4 Project changes and design refinements

The EIS for the project was prepared based on a concept project design (refer Chapter 5 of the EIS). This design has since been refined to account for design changes and in response to submissions received during exhibition of the EIS.

The Northern Road upgrade -
Mersey Road to Glenmore Parkway
**Construction Boundary and
Compound Sites**

Figure 4-2 | Comparison of EIS and refined design construction footprints

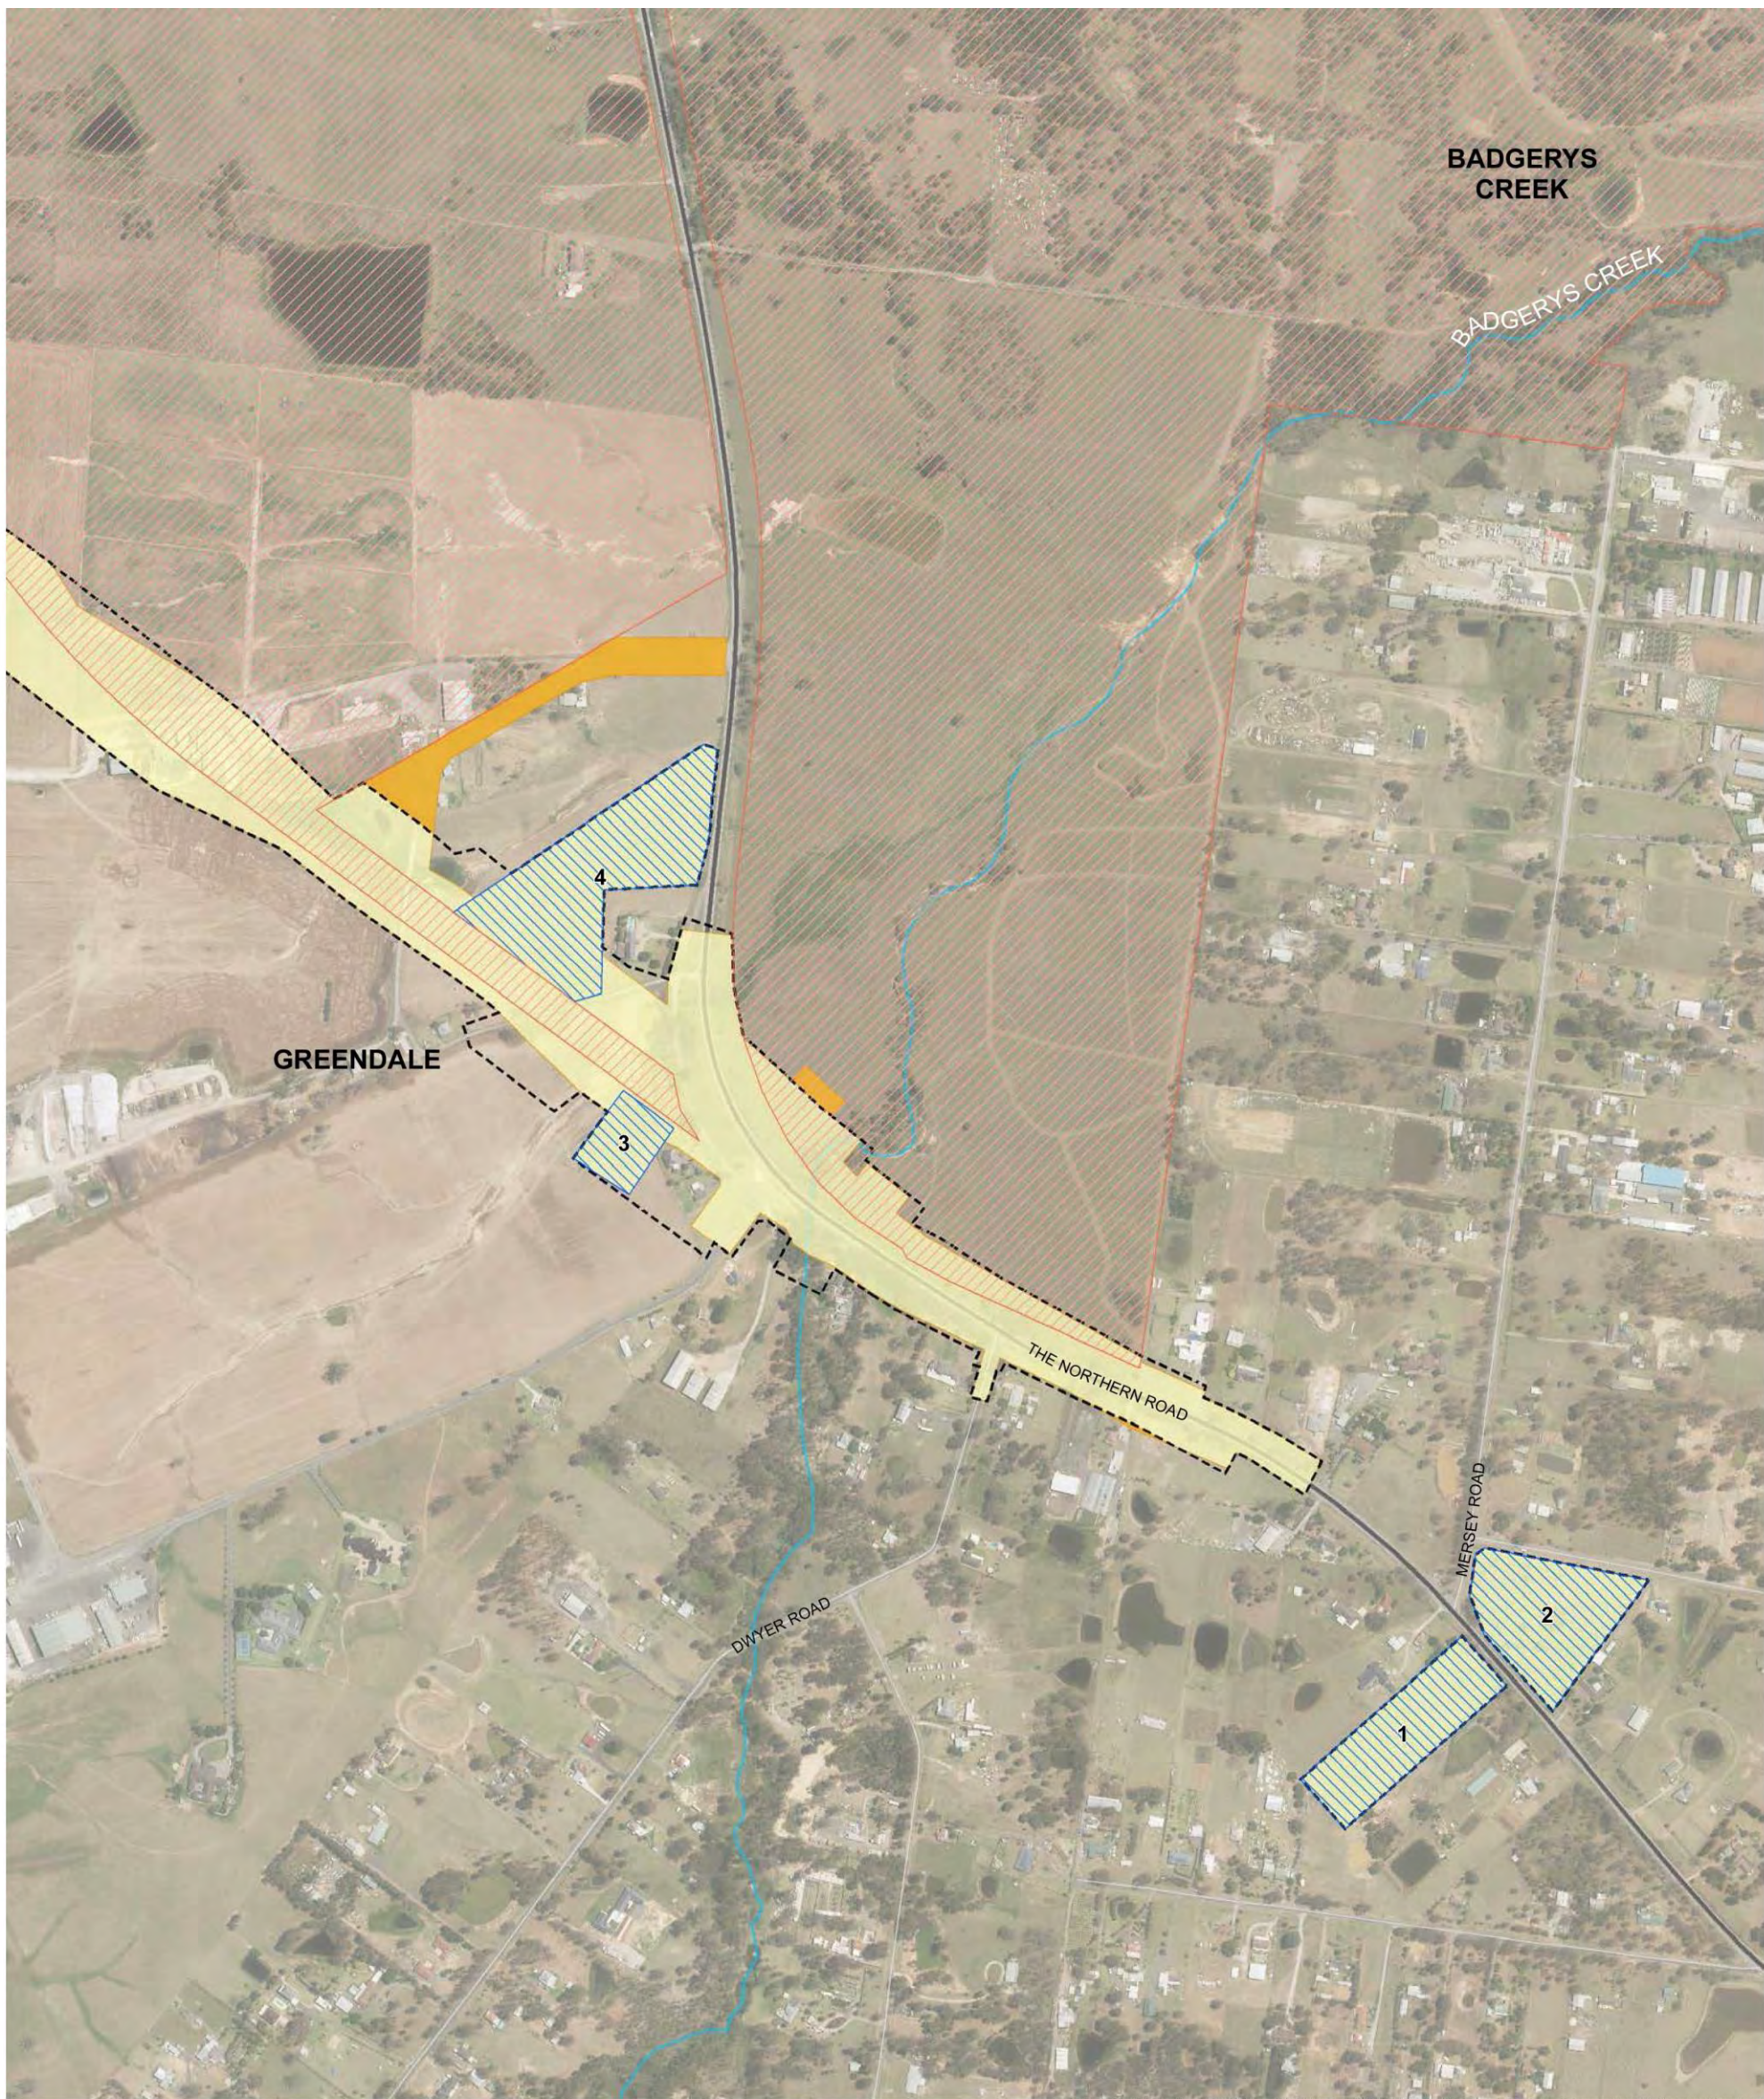
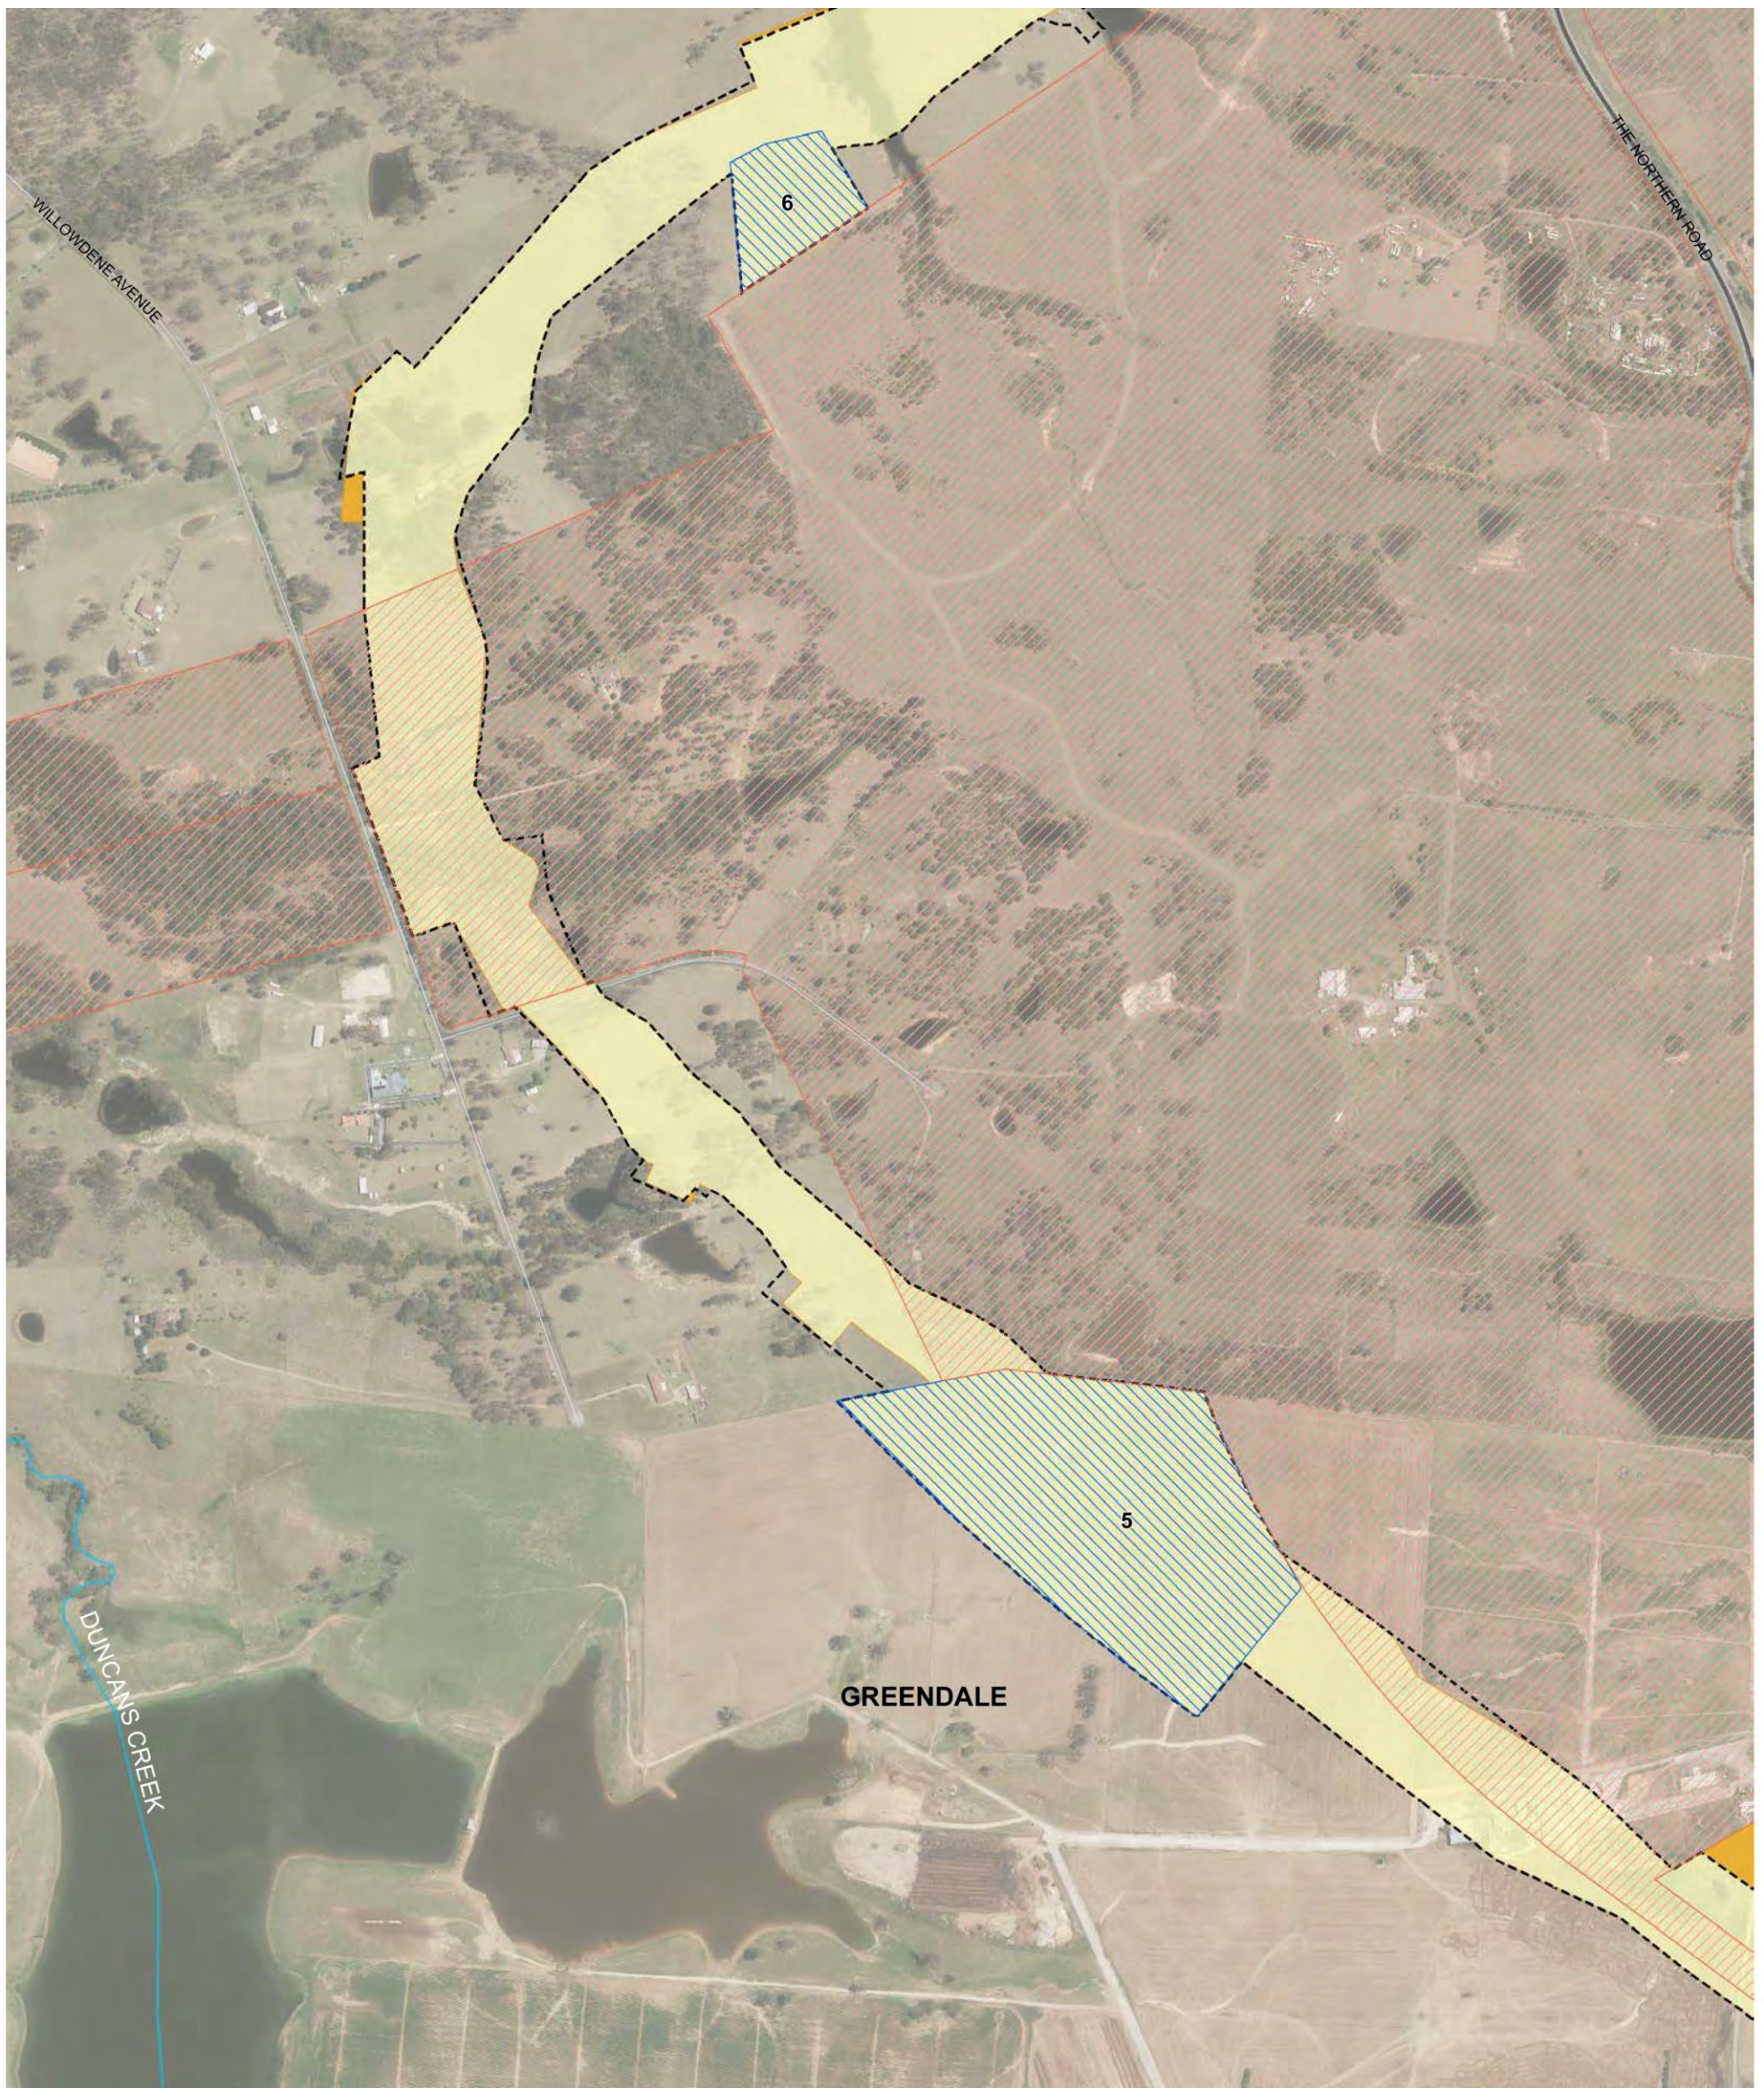
Table 4-2 provides a comparison of the construction and operational footprints calculated for the design refinements against the footprints assessed in the EIS, with reductions of 10 ha and 16 ha identified respectively. An error in the EIS footprint calculations (EIS – original) was identified during the footprint assessment which has been corrected in the table (EIS – revised).

Figure 4-2 provides a comparison of the EIS and the refined design construction footprints. Figure 4-3 provides a comparison of the EIS and the refined design operational footprints.
